SAFETY RECALL BULLETIN

NHTSA RECALL 22V437

AUTOCAR, LLC SAFETY RECALL ACX-2203

Autocar, LLC has determined that a defect which relates to motor vehicle safety exists in certain Xpeditor (ACX) chassis. The external fuse box may short circuit due to water intrusion.

Figure 1

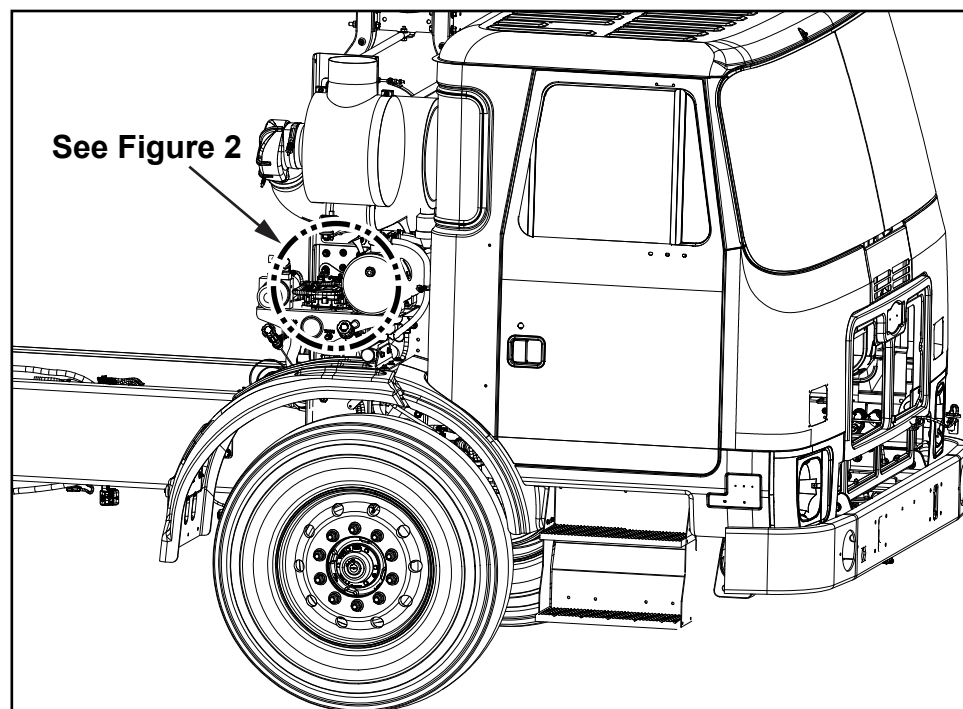
1. Follow all lockout/tagout procedures and verify the battery disconnect switch is in the “OFF” position. If the unit is not equipped with a battery disconnect switch, disconnect the battery cables beginning with the negative cables, followed by the positive cables.
2. Locate the external fuse box on the outboard side of the right upright (see Figure 1).

Figure 2

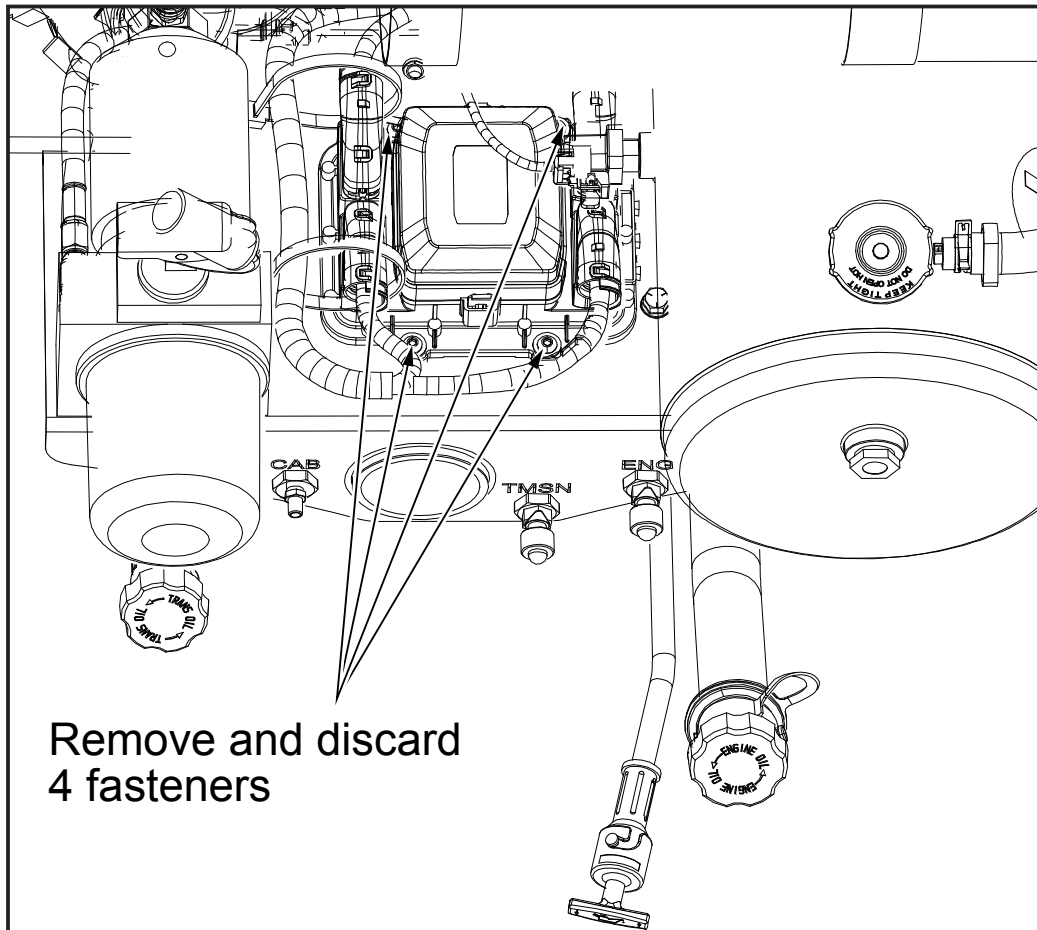
3. Locate the external fuse box, remove and discard the four mounting fasteners (see Figure 2).

Figure 3

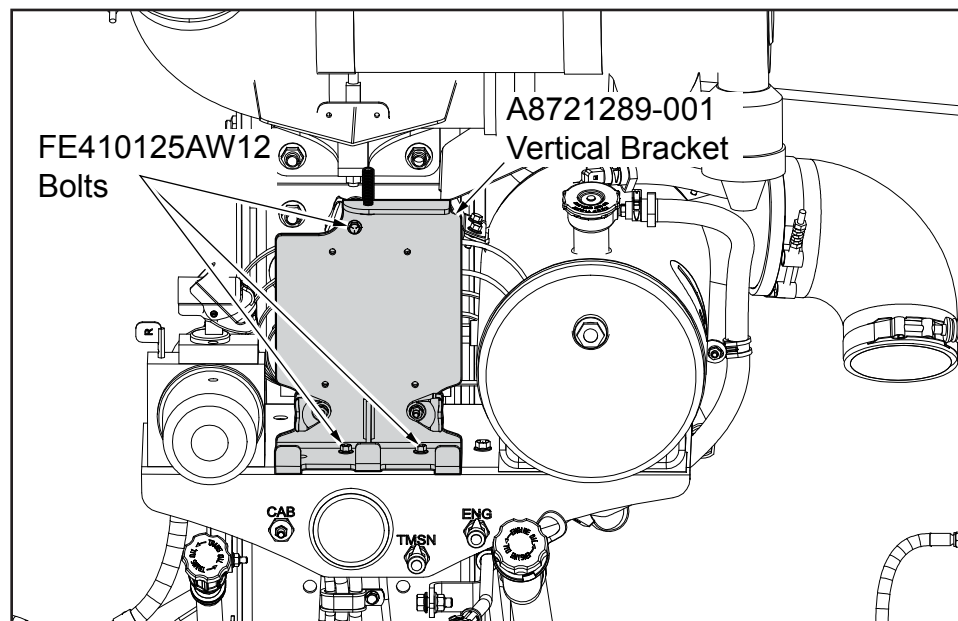
- Using three FE410125AW12 Bolts, install the A8721289-001 Vertical Bracket (see Figure 3).

Figure 4

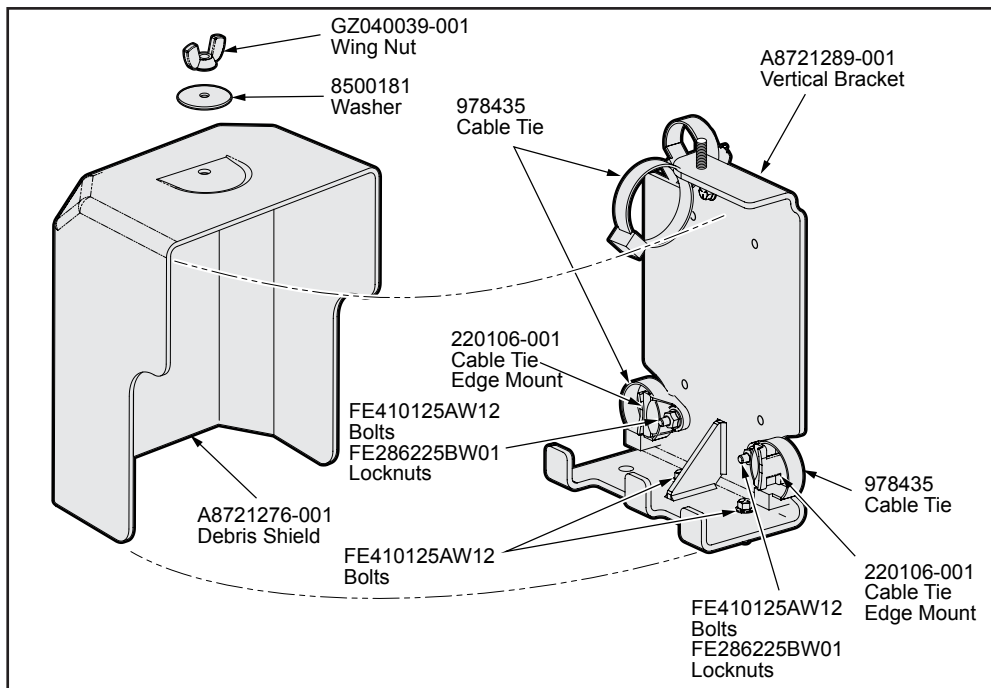
5. Install three 220106-001 Cable Tie Edge Mounts onto the Vertical Bracket and four 978435 Cable Ties (see Figure 4).
6. Install four FE410125AW12 Bolts and three FE286225BW01 Locknuts (see Figure 4).

8. Using four FE410125AW12 Bolts, reinstall the FB3 Fuse Box (see *Figure 7*).
9. Install the new A8721276-001 Debris Shield, 8500181 Flat Washer and the GZ040039-001 Wing Nut (see *Figure 4*).

Figure 5

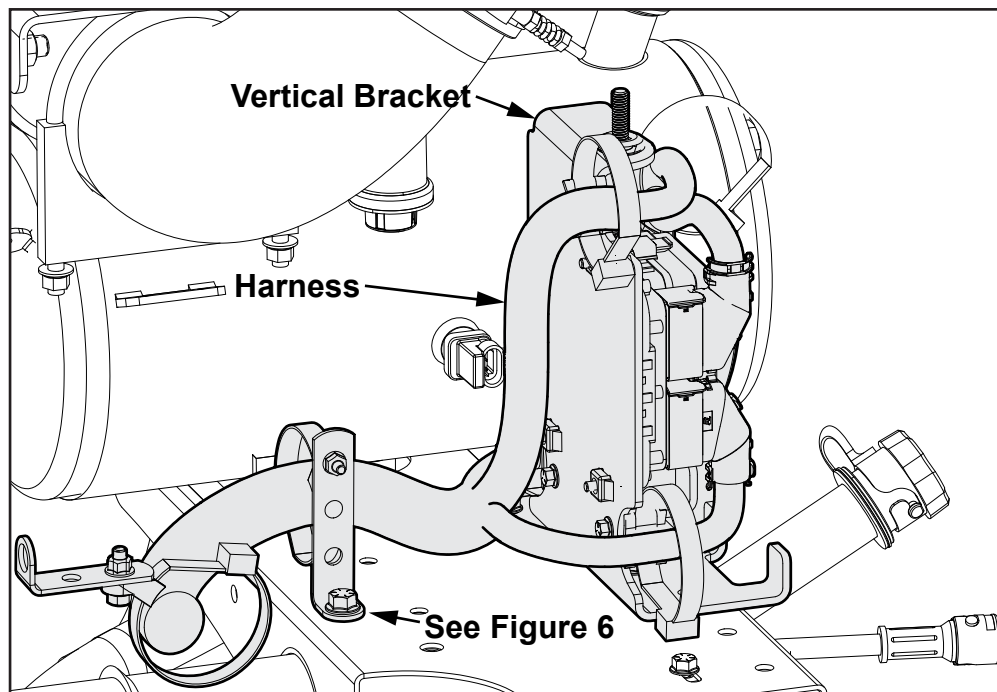
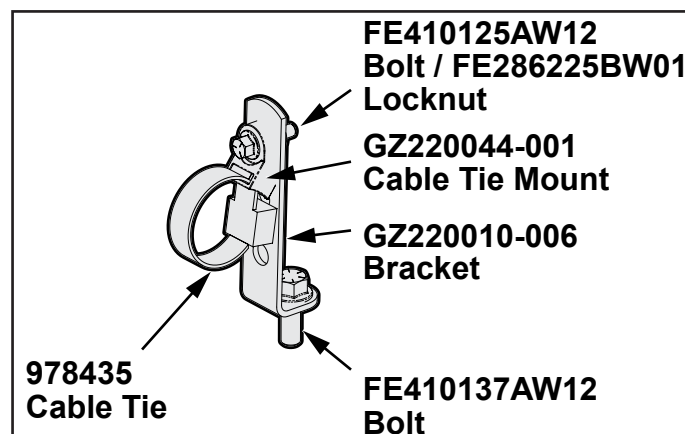
- Install the GZ220010-006 Three Hole Bracket and two FE410125AW12 Bolts. Install FE286225BW01 Locknut and GZ220044-001 Cable tie mount with 978435 Cable tie and FE410137AW12 Bolt. Route and secure harnesses as illustrated (see Figures 5 and 6).

Figure 9

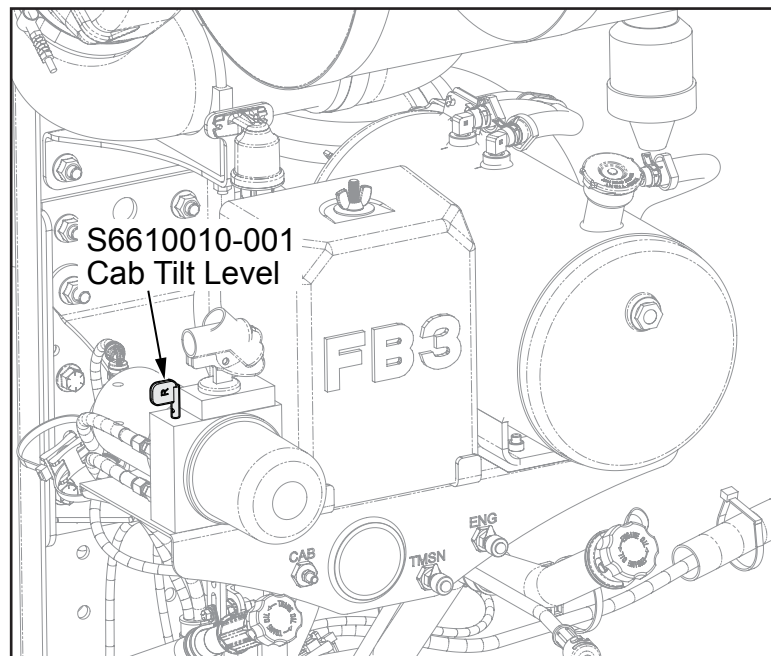
11. Install the 1" S6610010-001 Cab Tilt Lever (see Figure 9).
